UNITED STATES
NUCLEAR REGULATORY COMMISSION
WASHINGTON, D. C. 20555

June 17, 1988

SUBJECT: MINUTES OF CRGR MEETING NUMBER 137

Enclosure 3 to the Minutes of CRGR Meeting No. 137
Proposed Bulletin on Thermal Stresses in Piping
June 3, 1988

FARLEY 2 TEMPERATURE DATA

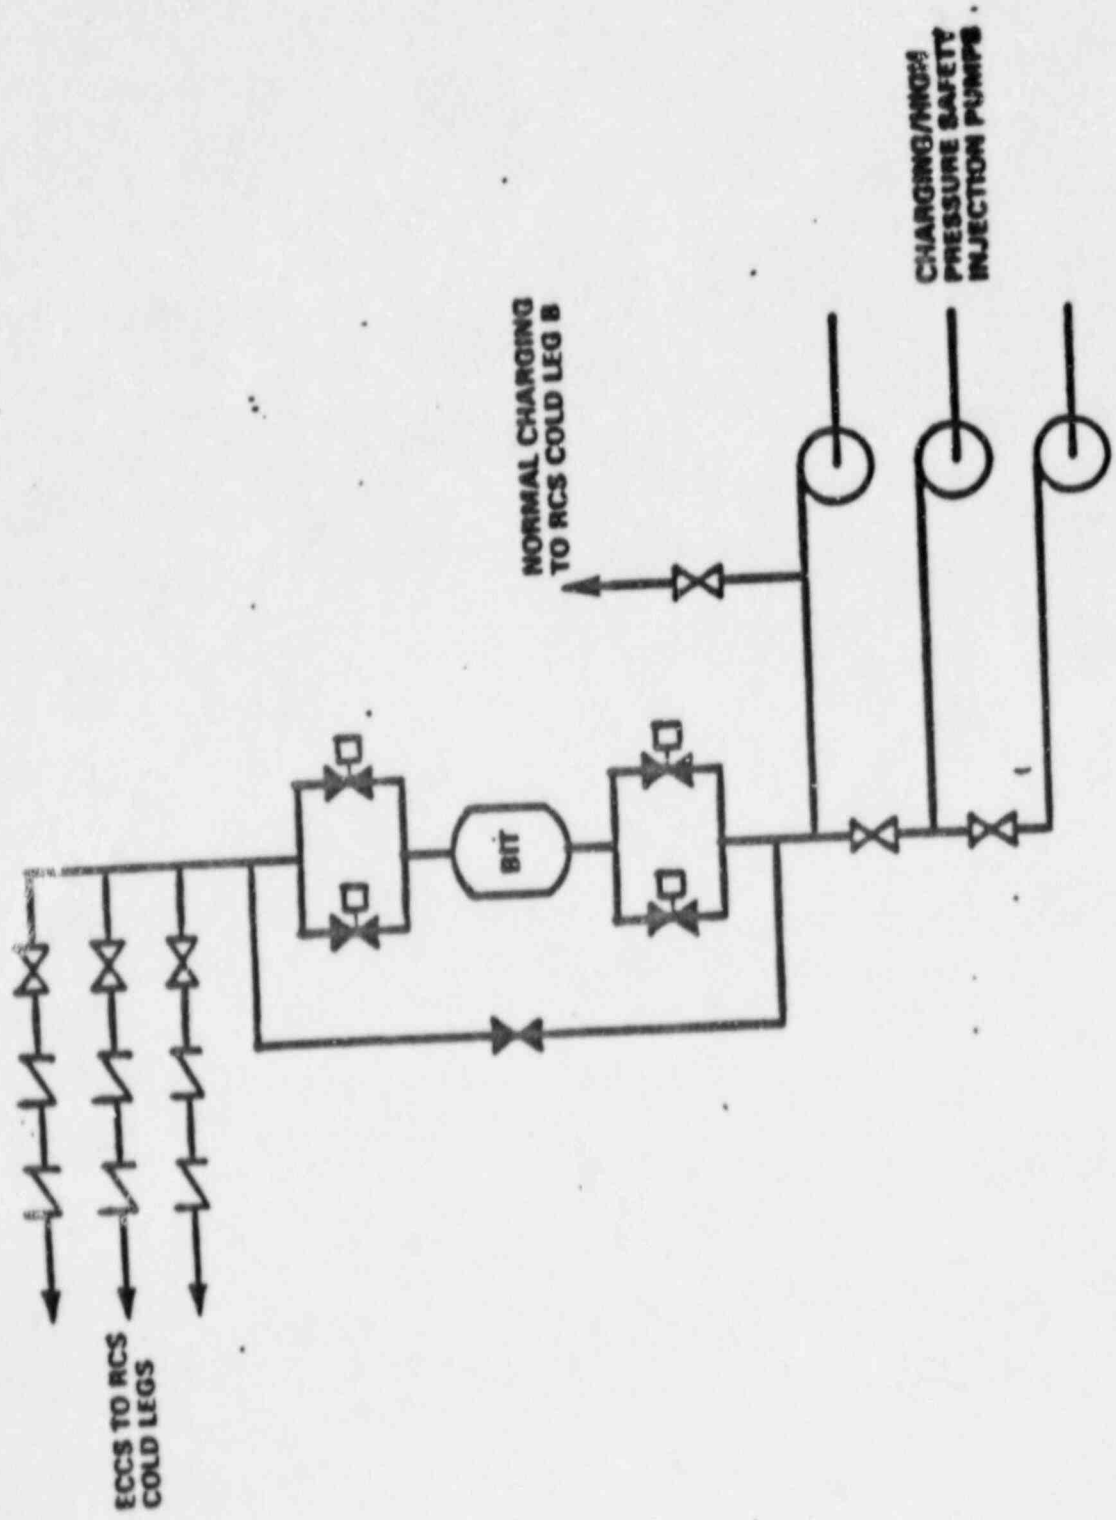
Then reexamine the remaining wording of that sentence (referring to double-ended failure), in comparison to the wording of the response to Question (viii) on p. 6 of Background Item 2 (referring to small-break LOCA), and revise as necessary for consistency.

BABCOCK AND WILCOX
Reactor Trip System
Oceana, TML CB-3, ANO-1, Rancho Seco

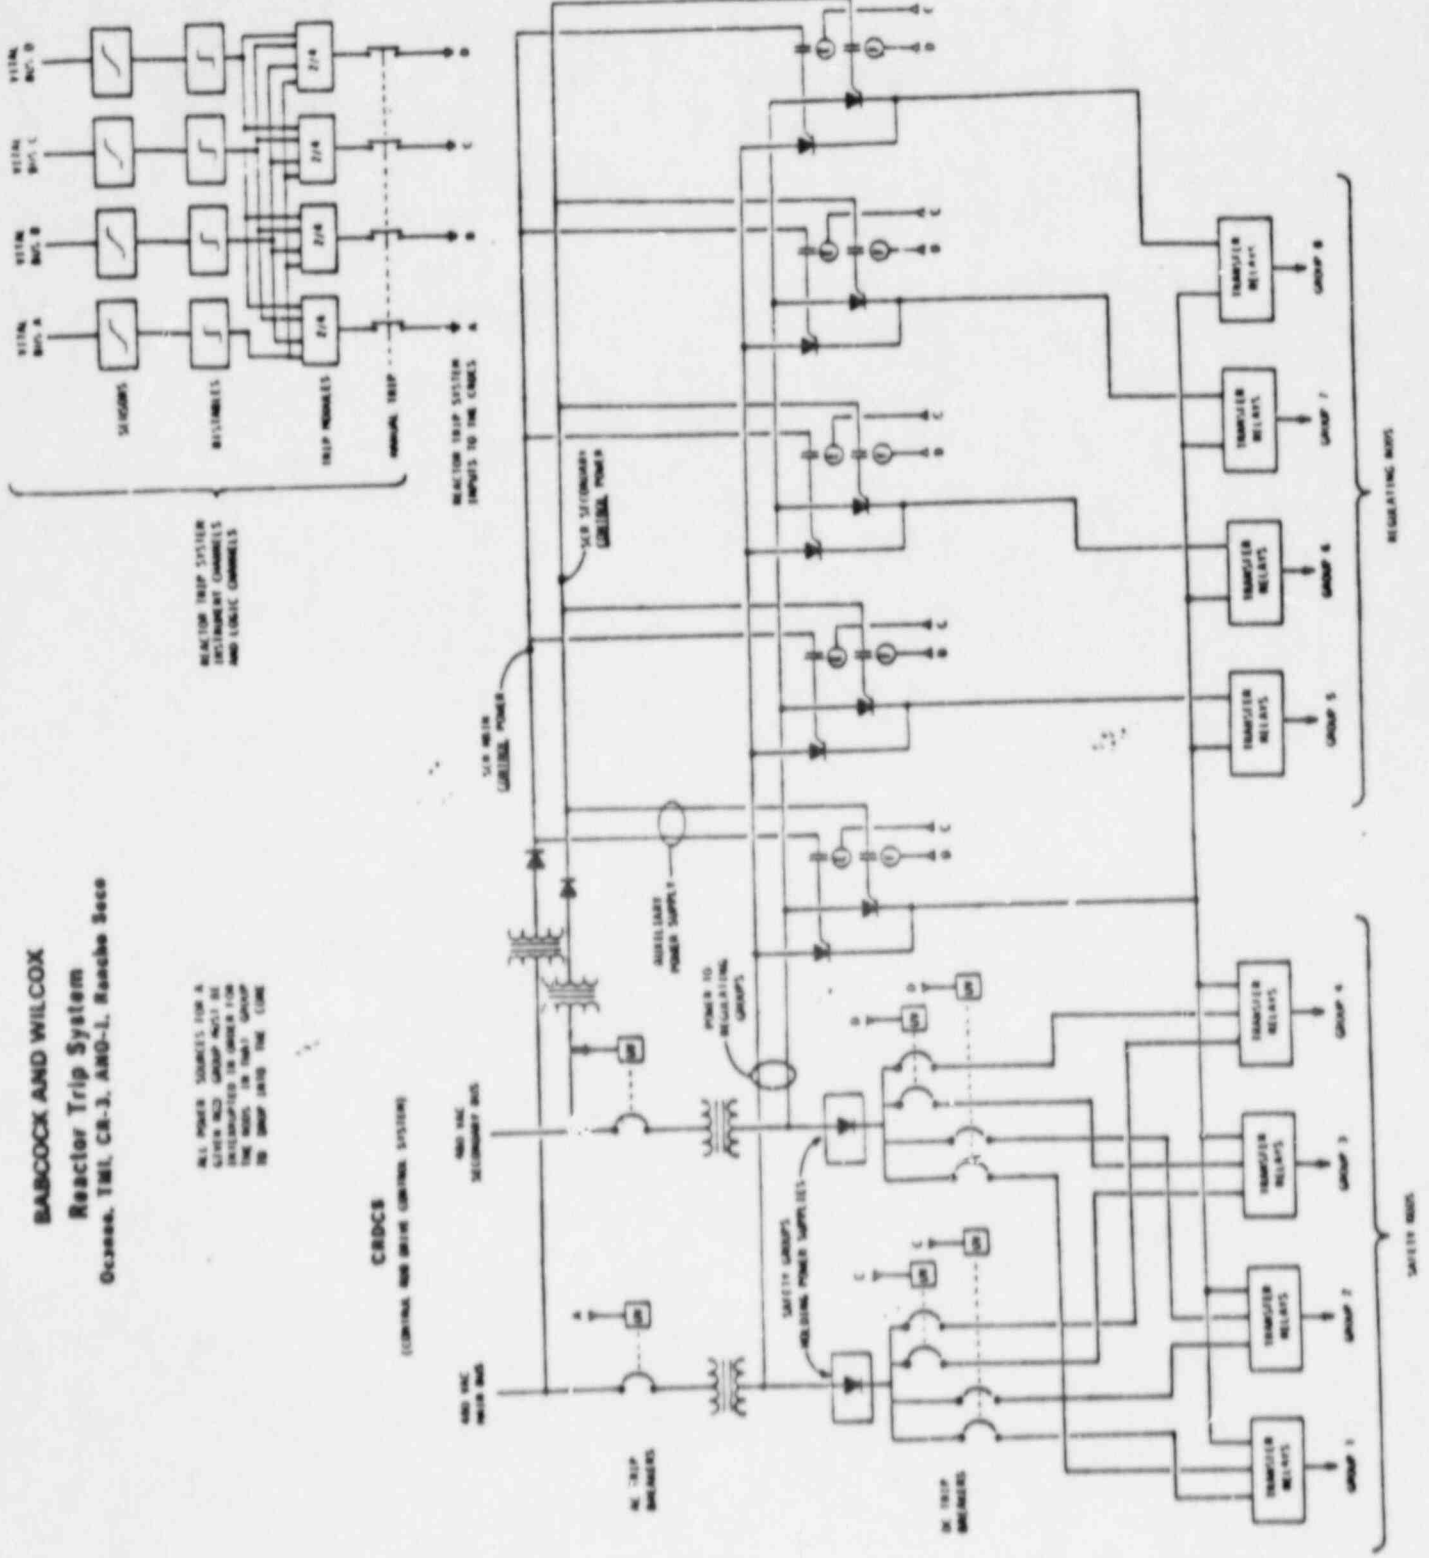
NOT REQUIRED, BUT MUST BE CAPABLE OF PERFORMING SAFETY FUNCTIONS WITH LOSS OF OFFSITE POWER. LOGIC POWER MUST BE FROM AN INSTRUMENT POWER SUPPLY INDEPENDENT FROM THE POWER SUPPLIES FOR THE EXISTING REACTOR TRIP SYSTEM. EXISTING RTS SENSOR AND INSTRUMENT CHANNEL POWER SUPPLIES MAY BE USED PROVIDED THE POSSIBILITY OF COMMON MODE FAILURE IS PREVENTED.

oo DESIGN REQUIREMENTS FOR THE USE OF POWER SUPPLIES AS DESCRIBED IN THE BWOG GENERIC DOCUMENT AND SUPPLEMENTAL LETTER 12/87 IS NOT ACCEPTABLE TO THE STAFF.

oo AN ACCEPTABLE METHOD IS PRESENTED IN SECTION 5.6 OF THE SER.

- o IF INDEPENDENT SEPARATE POWER SUPPLIES ARE USED, GENERIC APPROVAL CAN BE GRANTED
- o OTHERWISE, ISSUE BECOMES PLANT SPECIFIC AND WILL BE REVIEWED AS SUCH
- o OGC AGREES WITH THE STAFF'S POSITION CONCERNING INTERPRETATION OF POWER SUPPLIES
